NOVA SCOTIA ENERGY BOARD

IN THE MATTER OF: **An application by NOVA SCOTIA POWER
INCORPORATED (NS Power) for approval of approximately
\$284.0 Million of its Annual Capital Expenditure (ACE) Plan
for 2026 which totals \$702.1 million**

INFORMATION REQUESTS
(NON-CONFIDENTIAL)

From: Small Business Advocate

Figure 56: Evergreen IRP vs. 2026 ACE Plan Forecast Comparison by Unit⁵

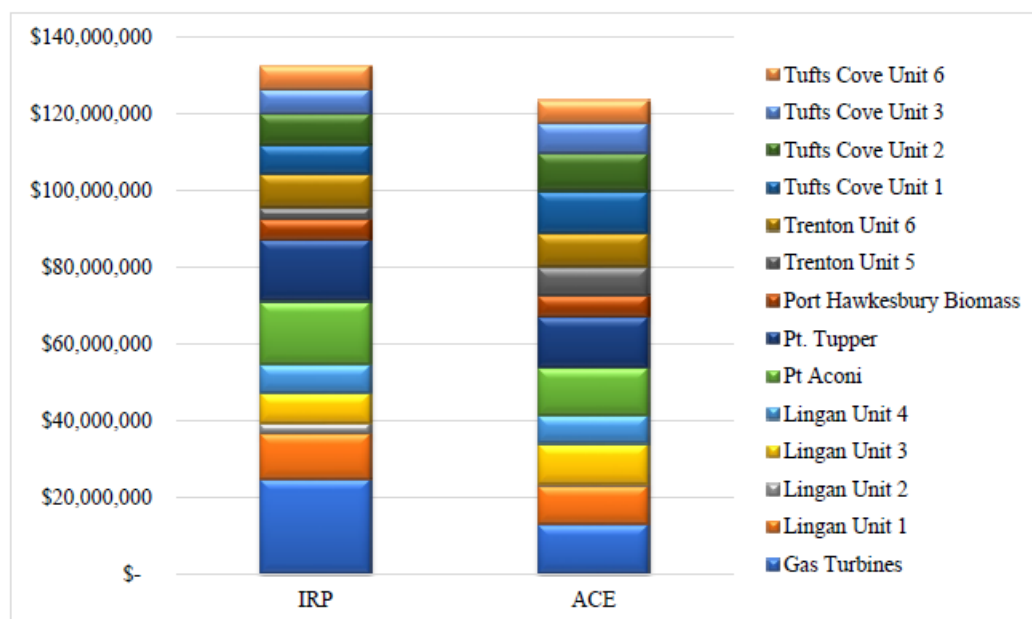
Refer the Application Section 11.1.1 Sustaining Capital, Page 88 of 782, Figure 56: Evergreen IRP vs. 2026 ACE Plan Forecast Comparison by Unit, shown below:

- a) Compared to the amount of investment in the last IRP shown on the left axis, please confirm which units shown on the right axis:

- i) have increased investment planned for 2026.
- ii) Have decreased investment planned for 2026.
- b) Please explain which of the CEJC rating criteria listed on Page 89 of 782, Lines 4-12 were relied on to determine this positive or negative change in investment level for each unit.
- c) Does NS Power expect or plan to have average annual investment levels for these units revert to the IRP planned amounts and if so, when?
